Date: May-27-19
To: Bidders for Norfolk County Bid No. PW-E-19-42
Delhi Wells 3A & 3B Upgrades
From: Scott Zerbes, Project Manager, Public Works
Scott.zerbes@norfolkcounty.ca
Subject: Addendum No. 4 (5 pages)

ADDENDUM No. 4

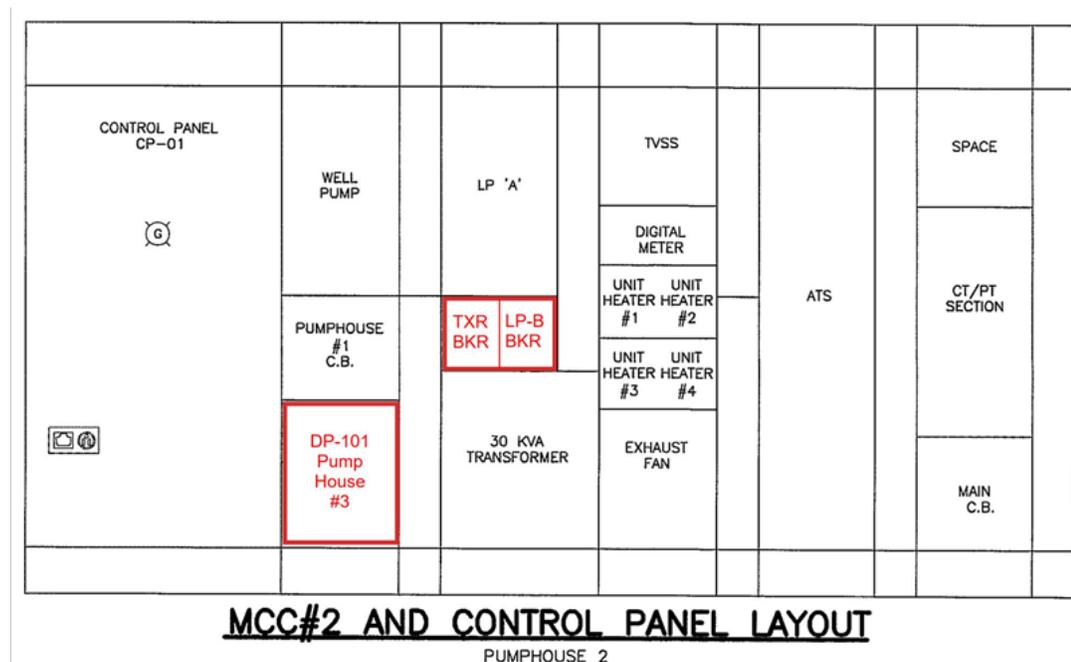
E103 Fig. 1 and 2 of existing MCC-2 shows the location of the new circuit breaker for wells 3A & 3B to be installed in available space located between the main hydro service and the ATS which will mean that the new wells will not be protected by standby generator, and this is not how it is shown on the single line diagram. Please confirm the location of the circuit breaker for the new wells.

Location of new circuit breaker to be revised as per description below:

- a) Remove existing TXR feeder bucket from MCC-2;
- b) Remove existing LP-B feeder bucket from MCC-2;
- c) Install new dual-mounted feeder tap bucket in MCC-2 (in the space of item #1 removal) with both TXR and LP-B breakers;
- d) Reconnect the power cables to the new bucket.
- e) Install new feeder bucket for DP-101 (Pump House #3) in MCC-2 (in the open place of former LP-B bucket);
- f) See sketch below with the final MCC-2 elevation.
